ADDENDUM #3

Project	Holy Family Catholic Elementary School	Project No.	2325
Location	1420 Grosvenor Street, Oakville, ON	Date of Issue	2024 04 09
Owner	Halton Catholic District School Board	File	2325/7.1.3

RE: Holy Family Catholic Elementary School
Renovations
Oakville, ON

ADDENDUM 02

RAISED CONCRETE BASE DETAIL

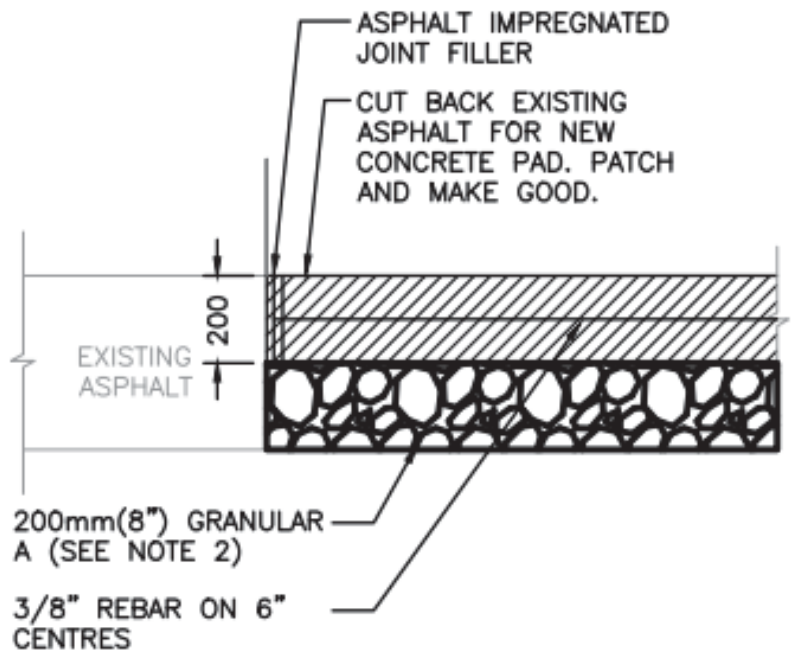
A3-2 GAS METER CONCRETE BASE DETAIL

- .1 Refer to attached image to include new reinforced concrete base for gas meter.

1. CONCRETE SPECIFICATIONS:
 CEMENT TYPE: NORMAL PORTLAND
 GU/PORTLAND LIMESTONE GUL
 MINIMUM 28 DAY COMPRESSIVE
 STRENGTH: 20 MPa
 MAXIMUM NOMINAL SIZE OF COARSE
 AGGREGATE: 19mm
 MAXIMUM WATER/CEMENTING
 MATERIALS RATIO: 0.45
2. GRANULAR A BASE MUST BE
 COMPACTED TO 100% SPMDD

Drawing Title
SITE PLAN, LEGEND AND OVERALL PLANS

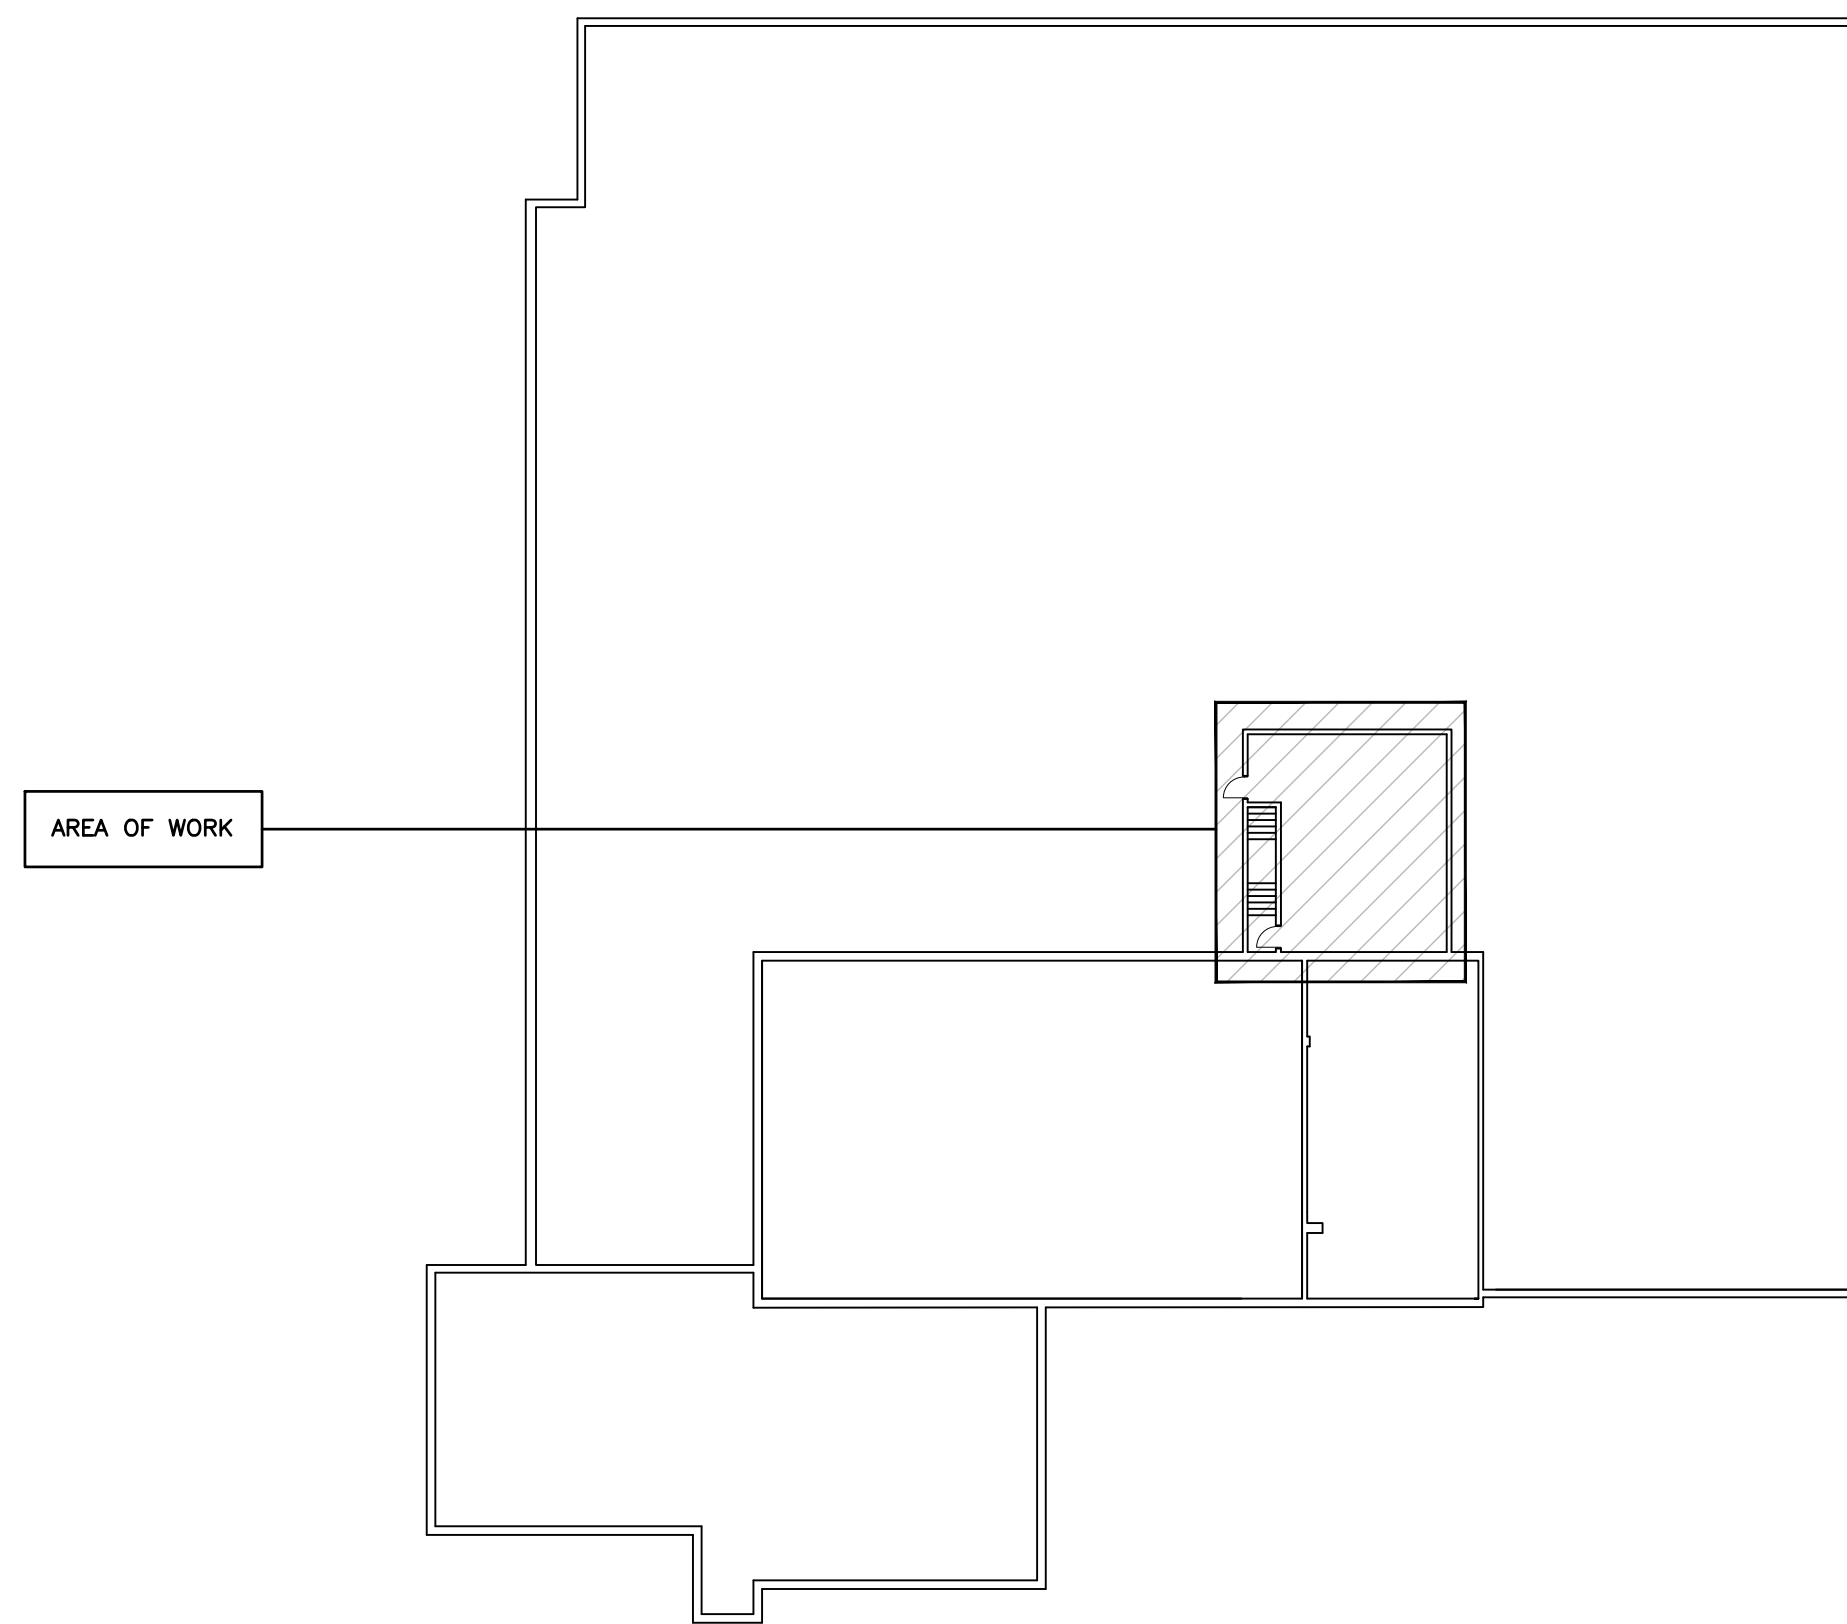
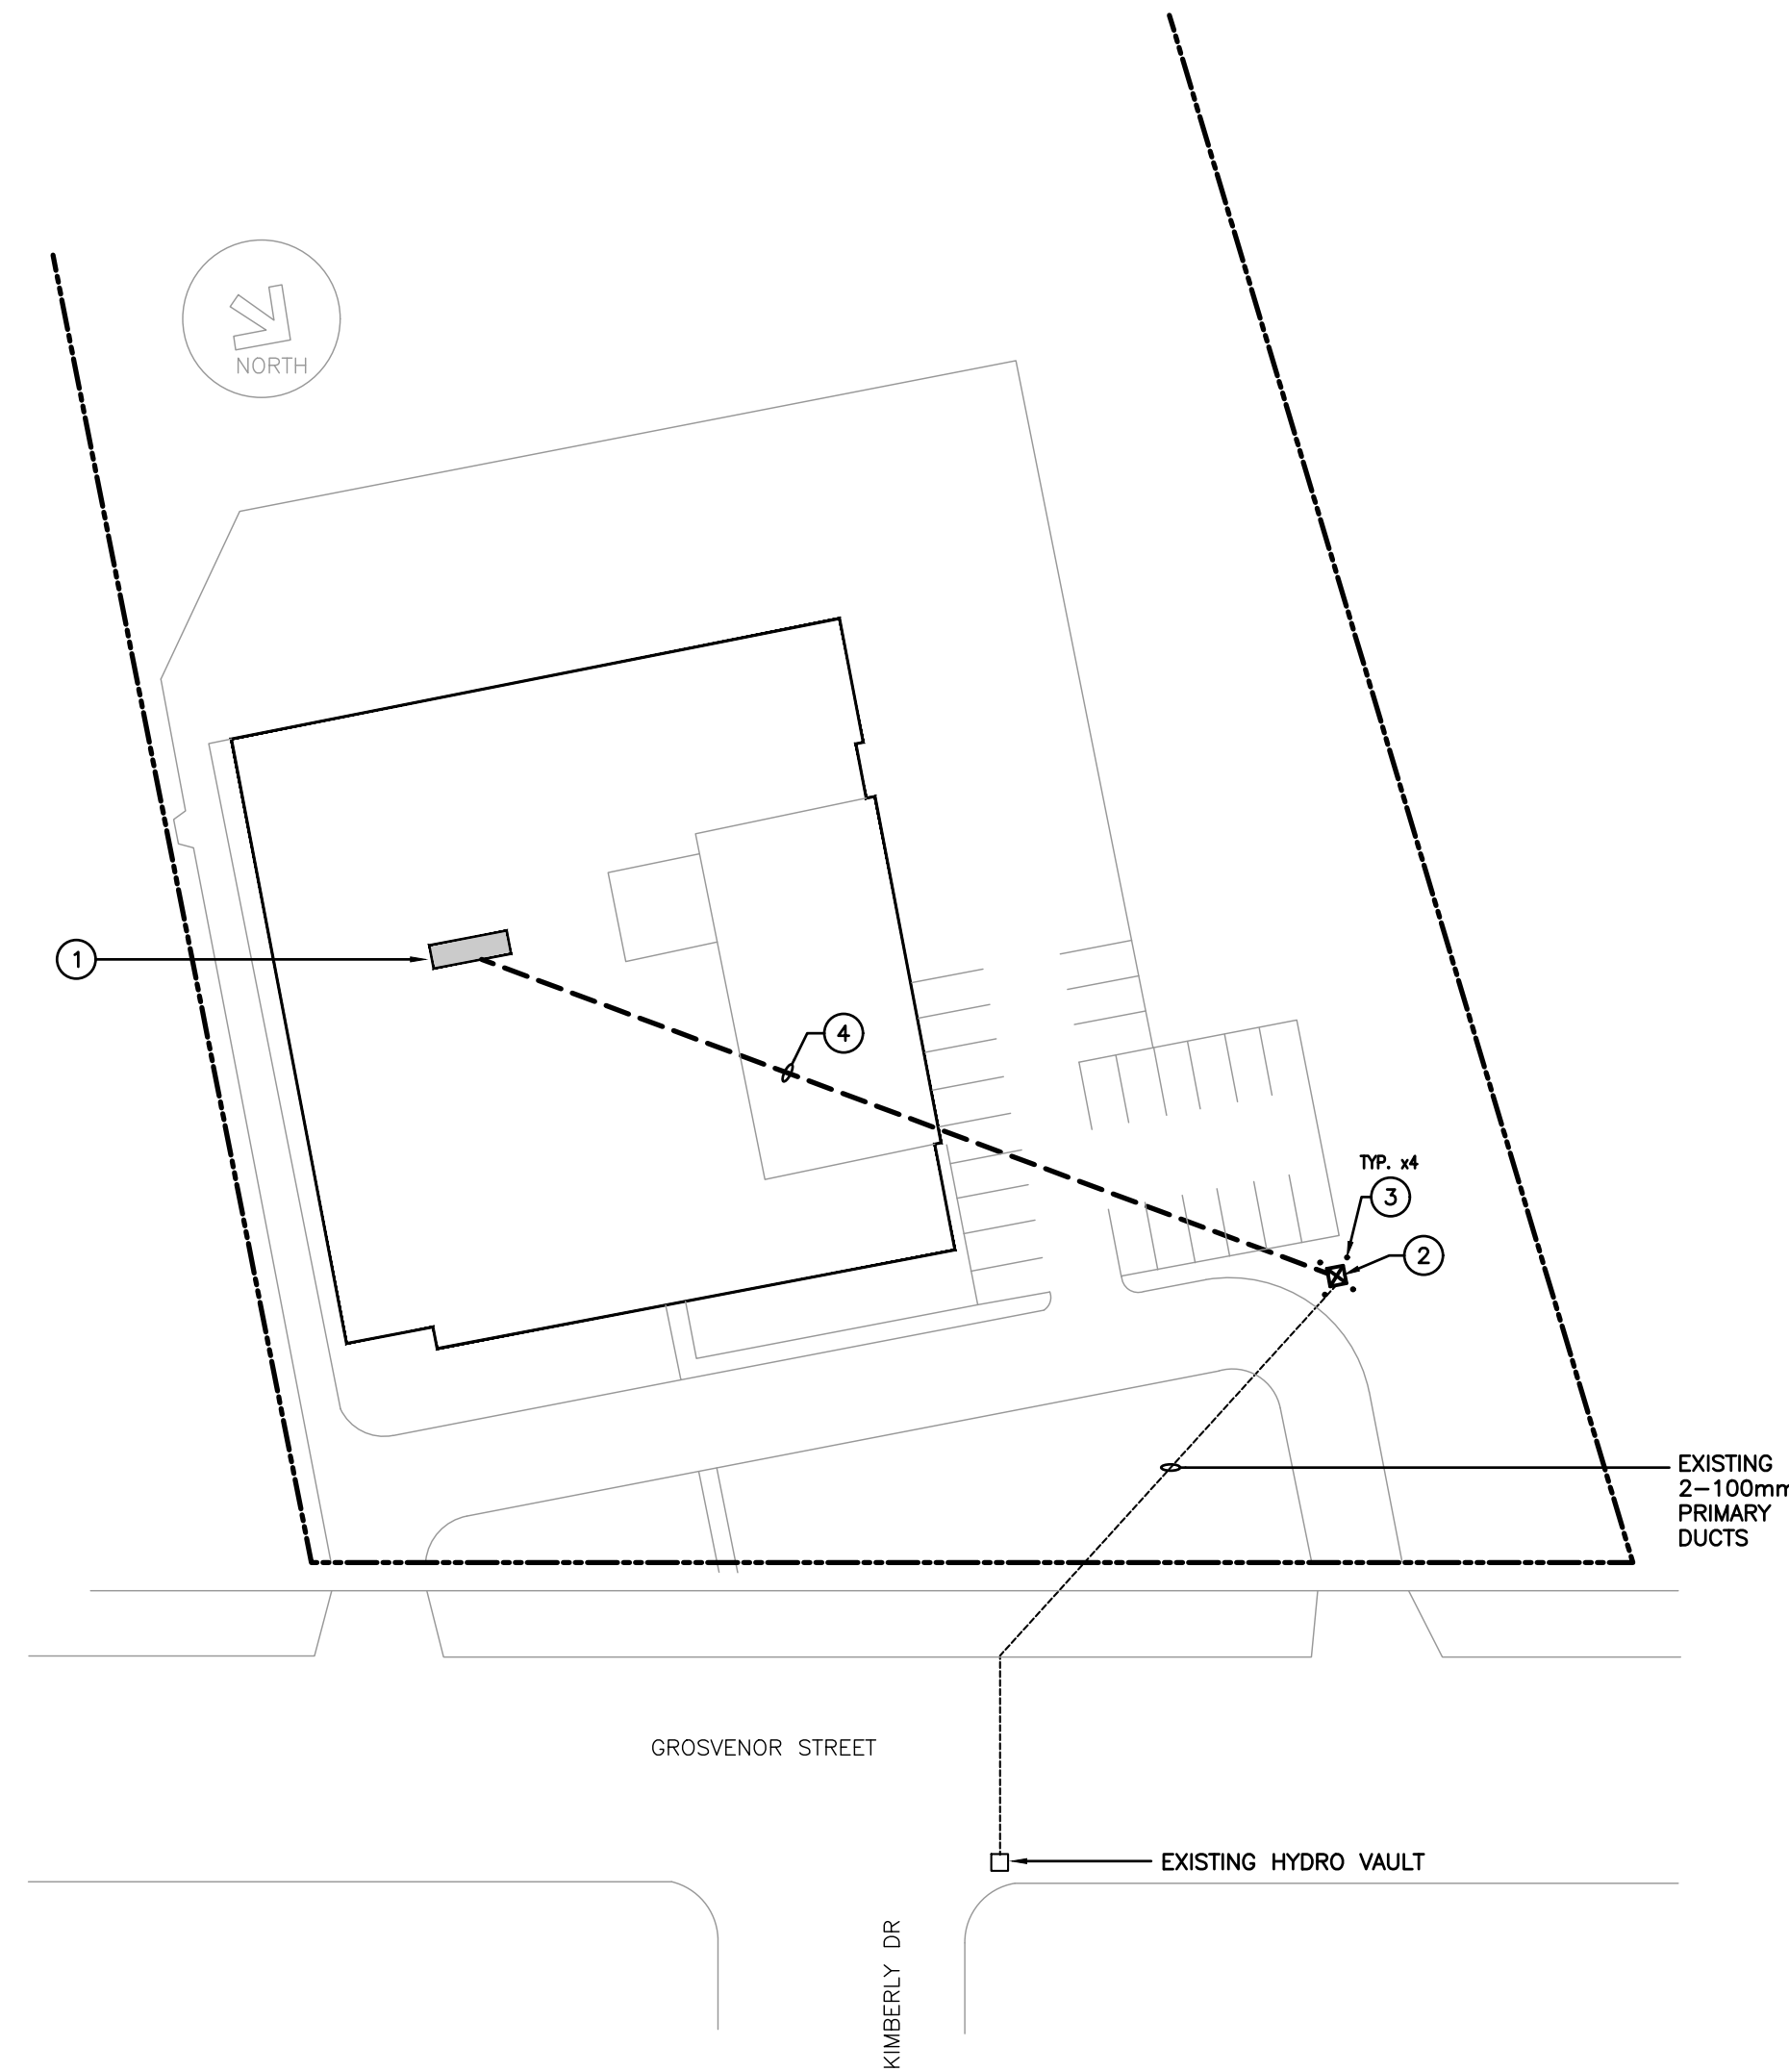
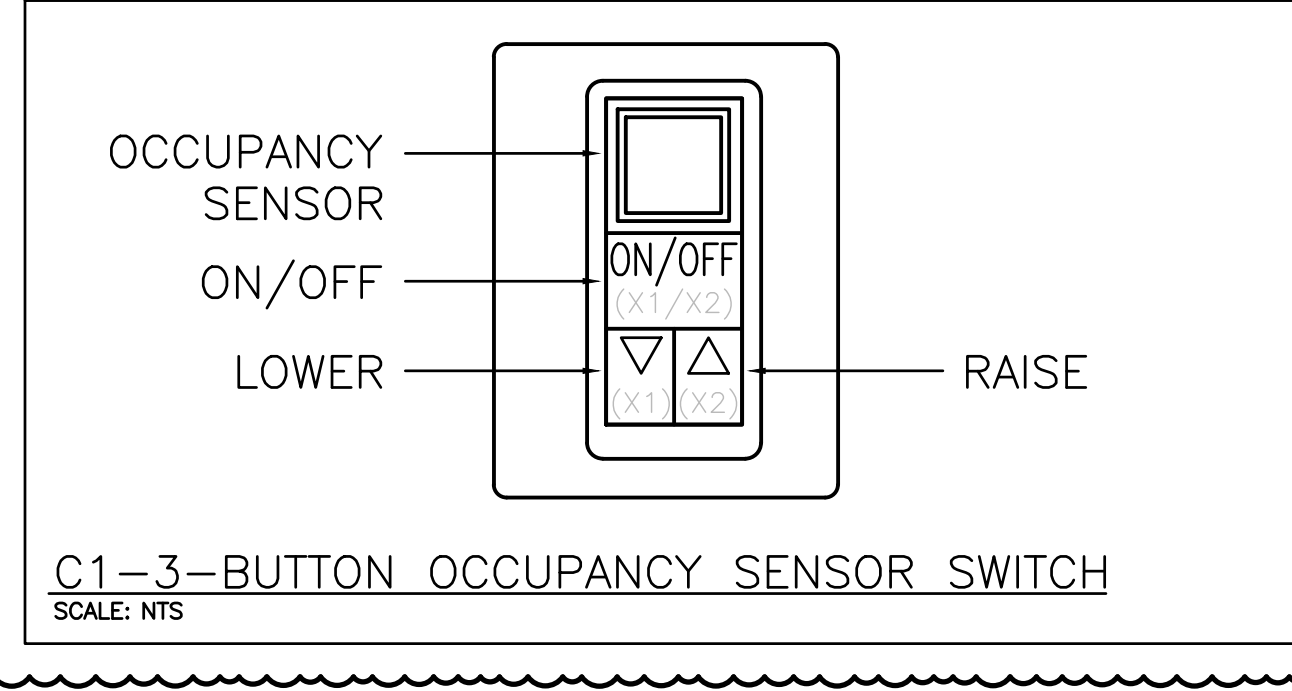
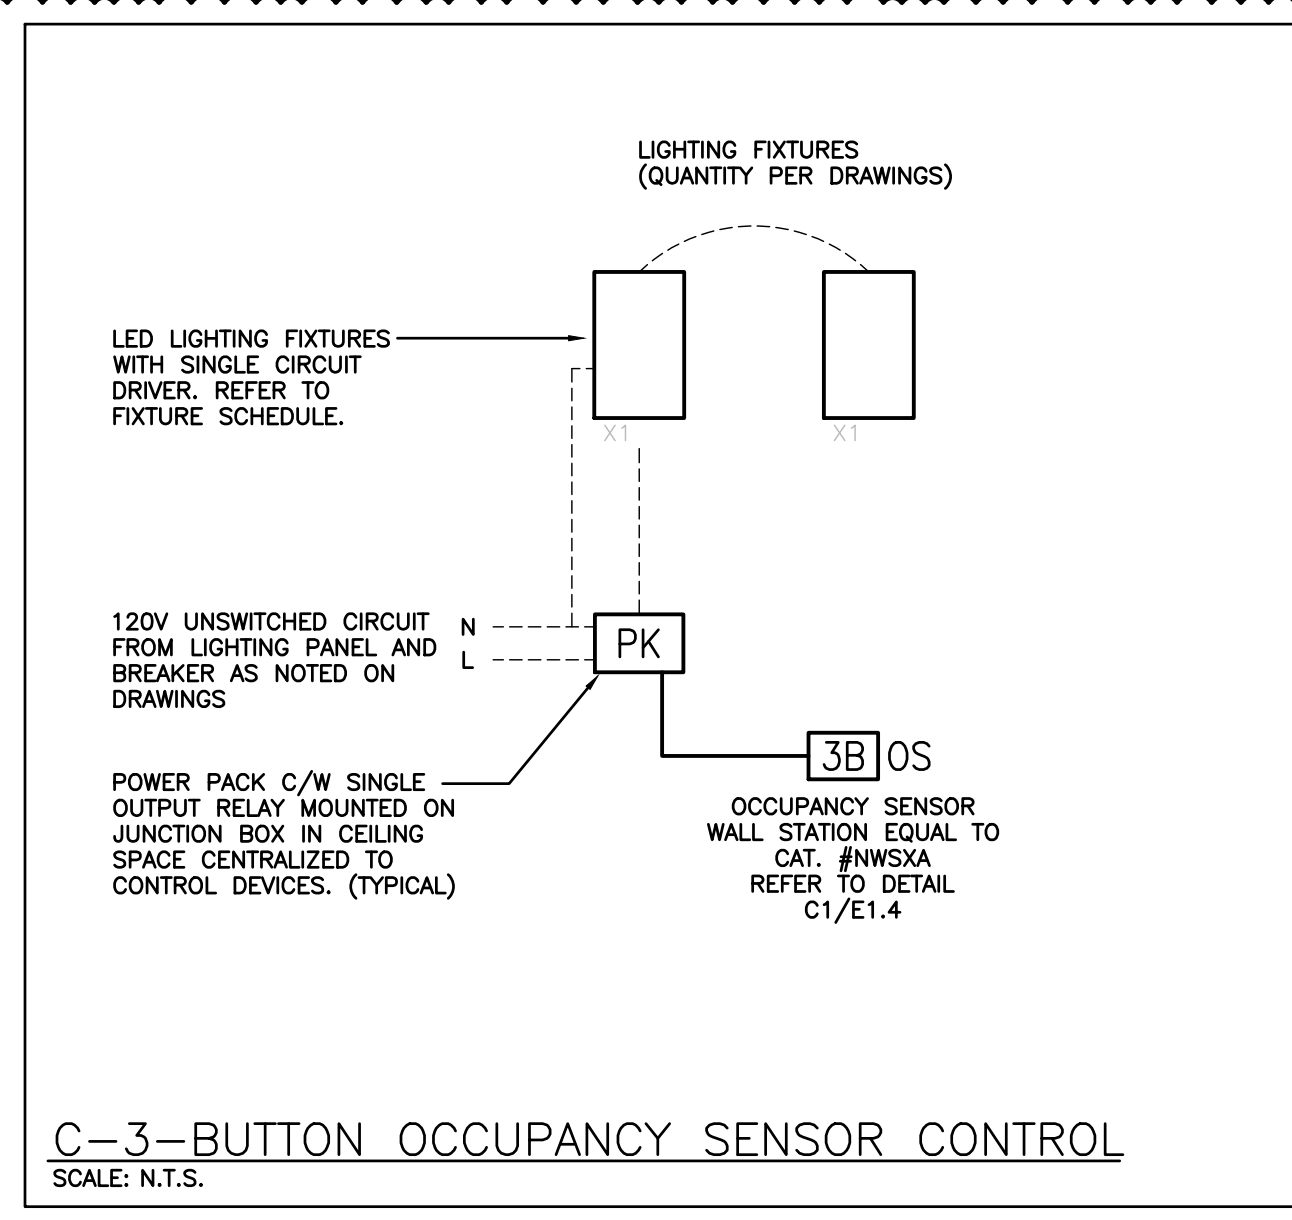
2.0 Reference Attached Reissued Drawing E1.1
.1 Revise notes #2 and #3 as shown.
.2 Remove detail A and B.
.3 Add 'ELECTRICAL SERVICE- SCOPE OF WORK'.

ELECTRICAL SERVICE-SCOPE OF WORK

OAKVILLE HYDRO (UTILITY) WILL PROVIDE THE FOLLOWING WORK. COST WILL BE PART OF THE ALLOWANCE FOR UTILITY WORK AS LISTED IN SPECIFICATIONS

- H1 ISOLATION/MAKE SAFE OF EXISTING SERVICE.
- H2 DISCONNECT, RECONNECT OR SUPPLY AND INSTALL OF PRIMARY FEEDERS.
- H3 PROVIDE NEW TRANSFORMER.
- H4 RECONNECTION OF SECONDARY FEEDERS.

THE ELECTRICAL CONTRACTOR FOR THE BUILDING OWNER (CUSTOMER) SHALL BE RESPONSIBLE FOR THE FOLLOWING:

- C1 REMOVAL AND DISPOSAL OF EXISTING SECONDARY CABLES BETWEEN TRANSFORMER AND SWITCHBOARD.
- C2 TESTING OF EXISTING DUCTS TO ENSURE SUITABILITY FOR RE-USE PER SPECIFIC NOTE 4.
- C3 INSTALLATION OF NEW SECONDARY CABLES IN EXISTING DUCTS.
- C3 GROUNDING AS PER ELECTRICAL CODE. PROVIDE COORDINATION STUDY PER SPECIFICATIONS.
- C4 ALL WORK SHALL MEET UTILITY REQUIREMENTS & INSPECTION. ELECTRICAL CONTRACTOR TO CO-ORDINATE WITH UTILITY PRIOR TO PROCEEDING.
